## **SDEIS Comments for SR520 Laurelhurst Community Club**

### **April 15, 2010**

**Exhibit Directory for SDEIS-Laurelhurst Community Club  
April 15, 2010**

The proposed second drawbridge: no help

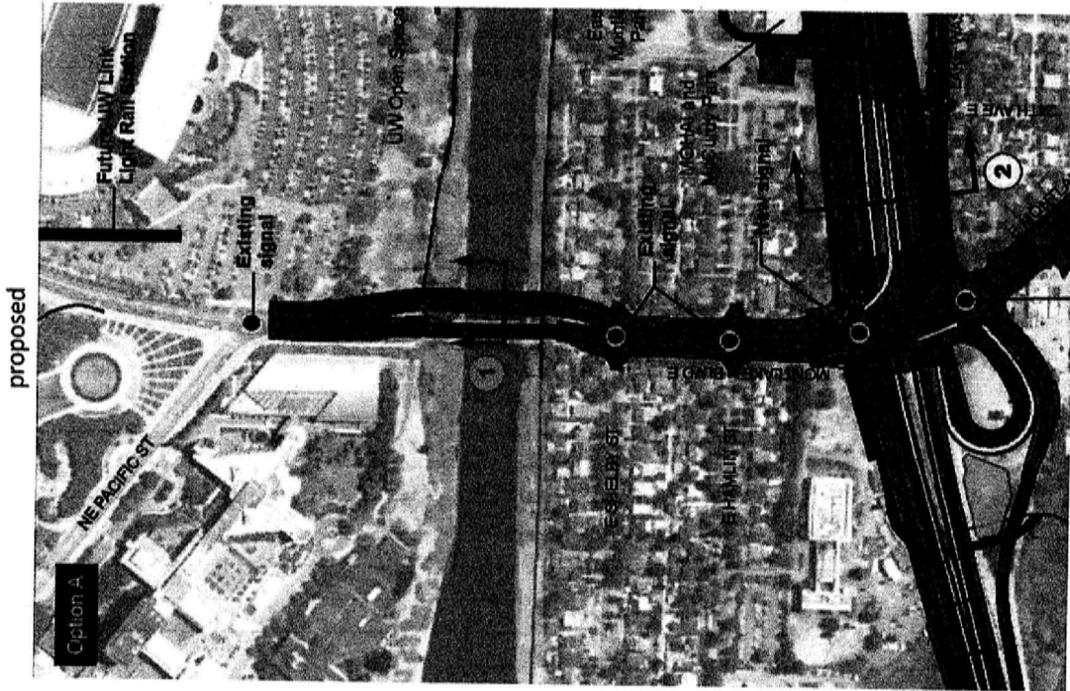
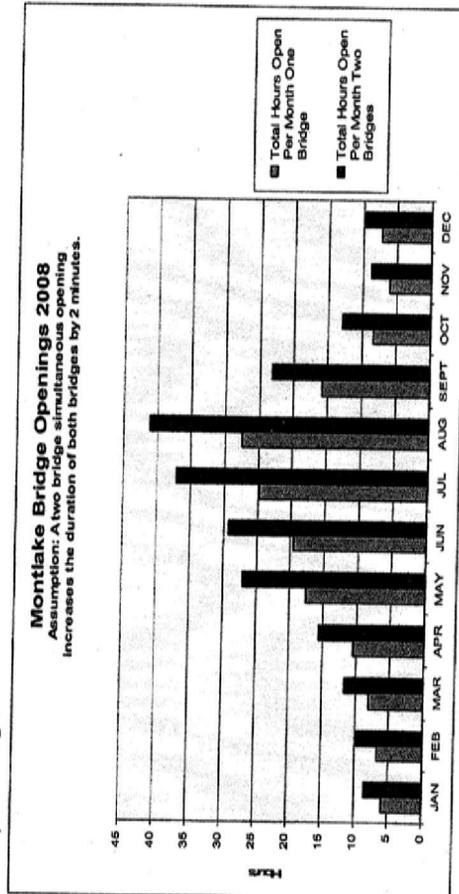
- All traffic going from 520 north now must go over the Montlake drawbridge. The bridge opens frequently, causing long traffic backups.
- The proposed 520 A adds a drawbridge just east of the current one. Traffic will still back up each time the bridges open.
- Stopping for a drawbridge makes bus timetables unreliable. Emergency vehicles for UW Hospital must stop and wait.
- A new bridge would detract from the beauty of the historic current bridge.
